# Access Compliance Report

## Public Rights-of-Way

### (Curb Ramps)

Intersection ID: 47613	Main Street: BATHURST_DR	Cross Street: MACQUARIE_LN	Location: NE
ADA ID: 3299F03C9D3E	Ramp Type: PerpDiag	Initial Pass/Fail: Fail	Overall Compliance: No
Severity Score: 10			
Codes/Mitigation Info/Possible Solution		Field Measurements/Component Compliance

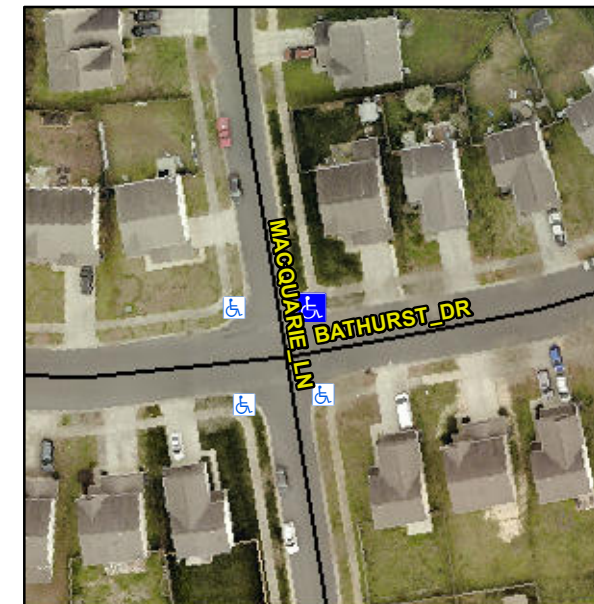
**Not Found, R304.5.1, R304.5.3**

Compliance	Description	Data	Compliance	Description	Data
N/A	Ramp Length (in)	54.0	Yes	Ramp Slope (%)	5.1
No	Ramp Width (in)	43.0	No	Ramp XSlope (%)	3.6
N/A	Flare Type LT	N/A	N/A	Flare Type RT	N/A
N/A	Flare Slope LT (%)	N/A	N/A	Flare Slope RT (%)	N/A
N/A	Flare Traversable LT?	N/A	N/A	Flare Traversable RT?	N/A
N/A	Landing Length (in)	N/A	N/A	DWS Provided?	N/A
N/A	Landing Width (in)	N/A	N/A	DWS Contrast?	N/A
N/A	Landing Slope (%)	N/A	N/A	DWS Length (in)	N/A
N/A	Landing X Slope (%)	N/A	N/A	DWS Full Width?	N/A
N/A	Landing Curb? (Y/N)	N/A	N/A	DWS Offset (in)	N/A
N/A	Shared Landing?	N/A			
N/A	Gutter Ponding?	N/A	N/A	Gutter Slope (%)	N/A
N/A	Gutter Lip Ht (in)	N/A	N/A	Gutter X Slope (%)	N/A
N/A	Painted X Walk1?	No	N/A	Painted X Walk2?	No
	X Walk 1 Direction	To W		X Walk 2 Direction	To S
N/A	X Walk 1 Width (in)	N/A	N/A	X Walk 2 Width (in)	N/A
	X Walk 1 Slope (%)	0.2		X Walk 2 Slope (%)	1.6
	X Walk 1 X Slope (%)	0.3		X Walk 2 X Slope (%)	0.1

**Remove & Replace Curb Ramp With Two New Directional Ramps or Equivalent.**
